COMMENT RESPONSE DOCUMENT

EASA PAD No. 18-098

[Published on 18 July 2018 and officially closed for comments on 15 August 2018]

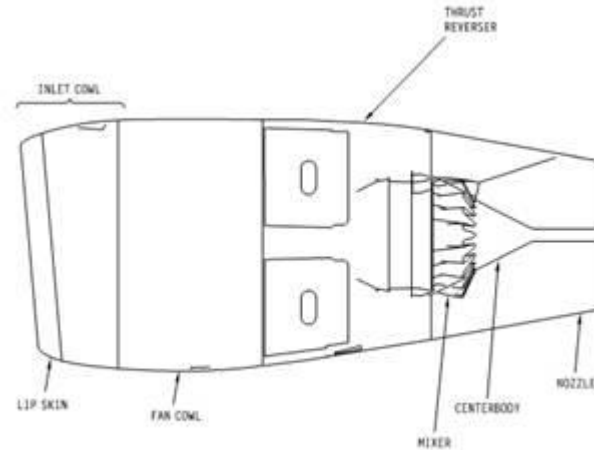
- D. For Information: The PAD describes that a not corrected OFS Panel disbond can lead to the in-flight loss of the Common Nozzle Assembly, [...]. LHT agree that a loss of the OFS Panel can lead to damage to the aircraft and/or injury to persons on ground but the engine mixer is bolted to the engine

via 96 bolts, the exhaust nozzle is fixed to the Mixer and will be hold in place via the V-Groove. Both [have] the [strength] to withstand the whole thrust that Engine can deliver. As the OFS Panel is made from Sandwich honeycomb, damage to the CNA might be occur but LHT has the opinion that even in a worst case scenario a partially or full loss of the OFS Panel will not lead to an in-flight loss of the CNA or the exhaust nozzle. Therefore LHT would be interested by getting more (technical) information why EASA is expecting a loss of the CNA?

D. Comment understood. The Common Nozzle Assembly (CNA) and Mixer interfaces are detailed in their two dedicated CMM.

Extract from CMM 78-11-21 (mixer description and operation 1.A (1)): “A bracket assembly on top of the mixer holds the front of the exhaust nozzle assembly in place when the thrust reverser doors are open.”

Extract from CMM 78-11-11 (Nozzle assembly- description and operation page1):

(3) When the thrust reverser C-ducts are closed, the nozzle attaches to the thrust reverser V-blade via a V-groove on the nozzle.

(4) When the thrust reverser C-ducts are opened, the nozzle rests on the mixer support pins and a six o'clock strut between the nozzle and mixer.

The 2 CMM explain that Nozzle Assembly rest on the mixer only when the TRU is opened, i.e. only for ground loads. For in-flight conditions, the CNA is only attached to the TRU thru the V-blade (configuration used for actual fleet plan).

Please note that the PAD states: “This condition, if not corrected, can lead to the in-flight loss of the common nozzle assembly, possibly resulting in damage to the aeroplane and/or injury to persons on the ground.” This is detailed in related Rohr SB RA78-0103 §1.C.(3): “Cause = The Hexcel CAA OFS panels are susceptible to wet ageing deterioration leading to a fatigue life limitation of 14,700 FC for the 6 O’C latch fitting.” This potential fatigue latch failure, due to loads redistribution following OFS disbond, could lead to TRU aft V-blade opening, and then to CNA in-flight loss.
